Dave Morey
Vice President
Farley Project

Joseph M. Farley Nuclear Plant
Submittal of License Amendment Request,
Correction to Technical Specification 5.6.5,
Addition of Elbow Tap Flow Measurement Methodology
and
Relocation of Cycle-specific Parameters

Attachment 3

Mark-up of the Technical Specifications

Figure 2.1.1-1
Reactor Core Safety Limits

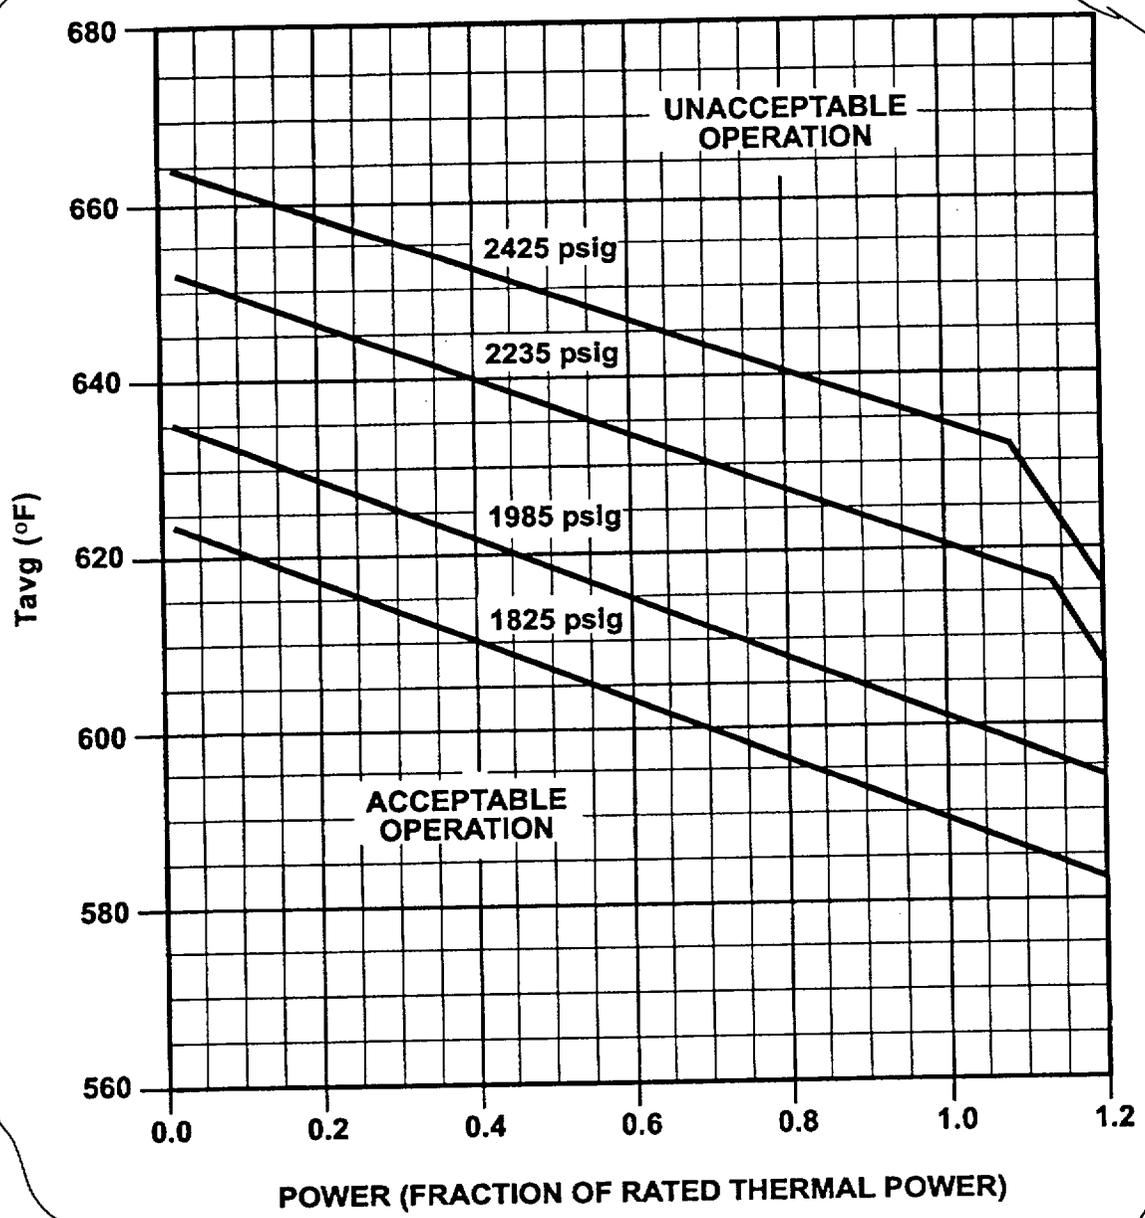
Revising TS 2.1, "Safety Limits," and the associated bases to replace figure 2.1.1-1 with more specific requirements regarding the safety limits.

RELOCATE TO COLR

Editorial Note:
DELETE PAGE

2.1.1.1 In MODES 1 and 2, the departure from nucleate boiling ratio (DNBR) shall be maintained within the 95/95 DNB criterion correlation specified in the COLR.

2.1.1.2 In MODES 1 and 2, the peak fuel centerline temperature shall be Maintained < 5080°F, decreasing by 58°F per 10,000 MWD/MTU.
